## **ADDENDUM NUMBER TWO**

IFB#23-912-34
THREE GENERATORS FOR GUSTE HIGH RISE

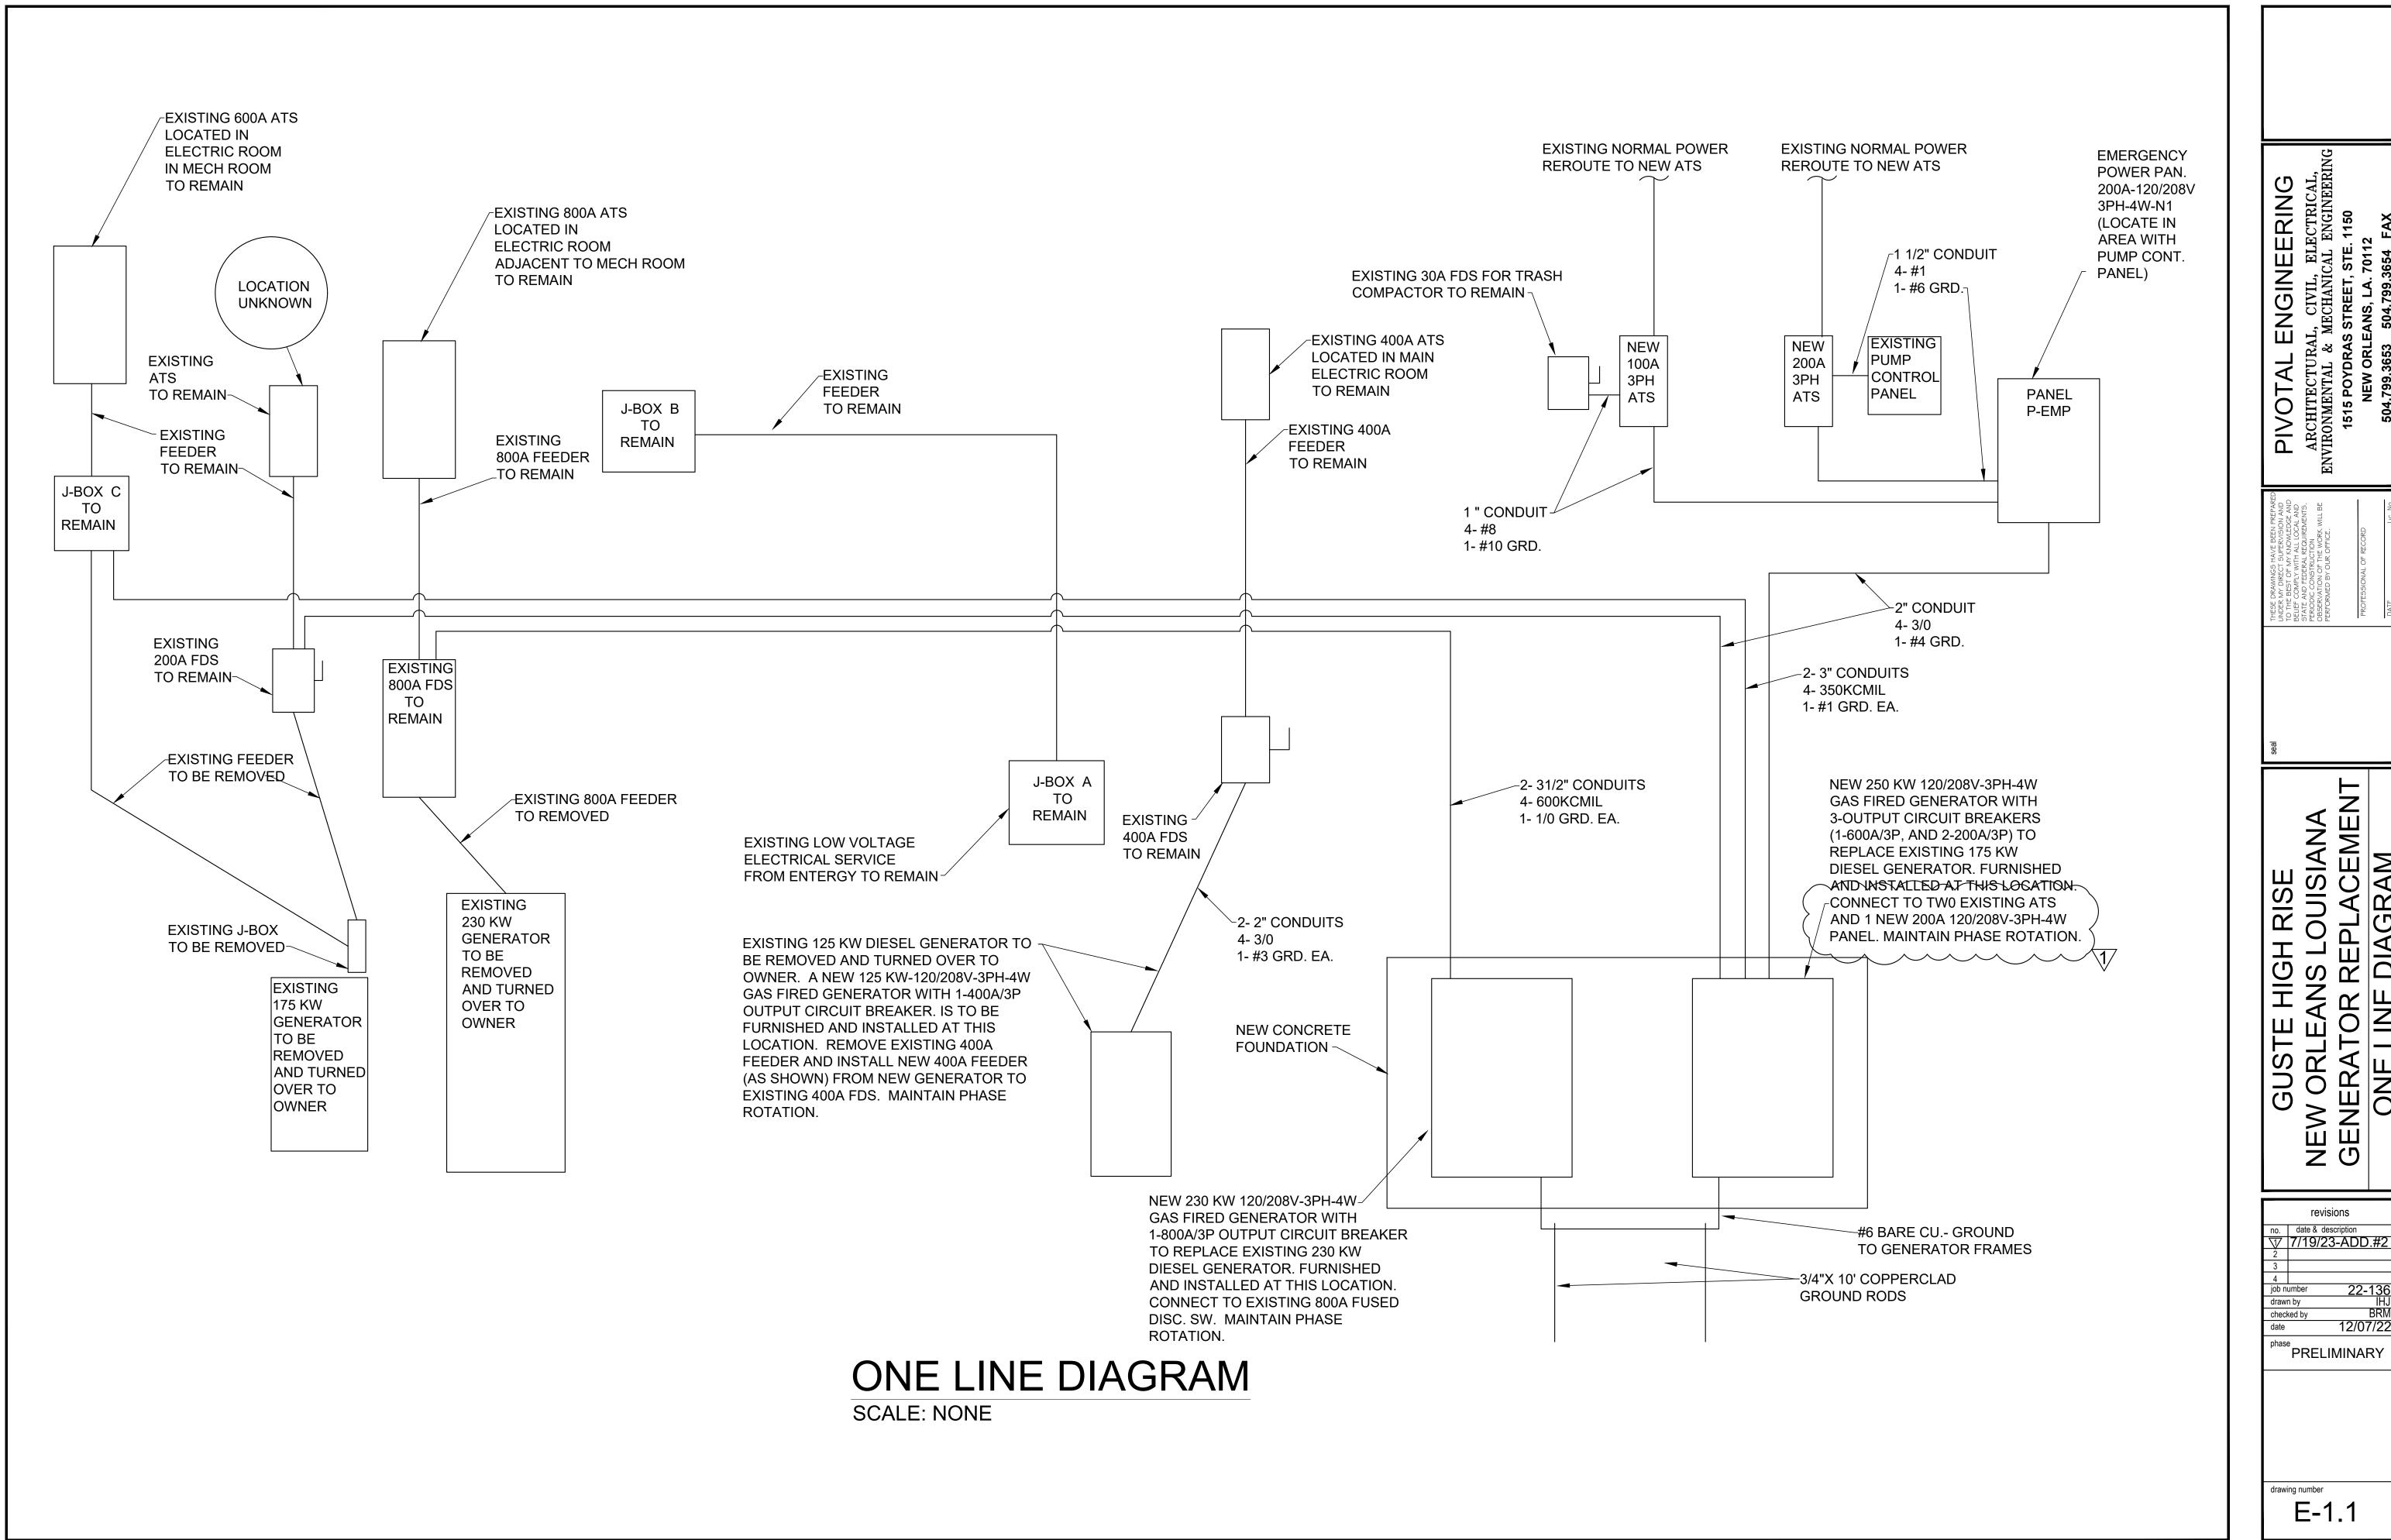
The revision cloud shown on sheet E-1.1 changes the note to the 250KW generator from "CONNECT TO TWO EXISTING ATS AND 1 NEW 200A 120/208-3PH-4W ATS" to "CONNECT TO TWO EXISTING ATS AND 1 NEW 200A 120/208V-3PH-4W PANEL". (See attached pg. 2)
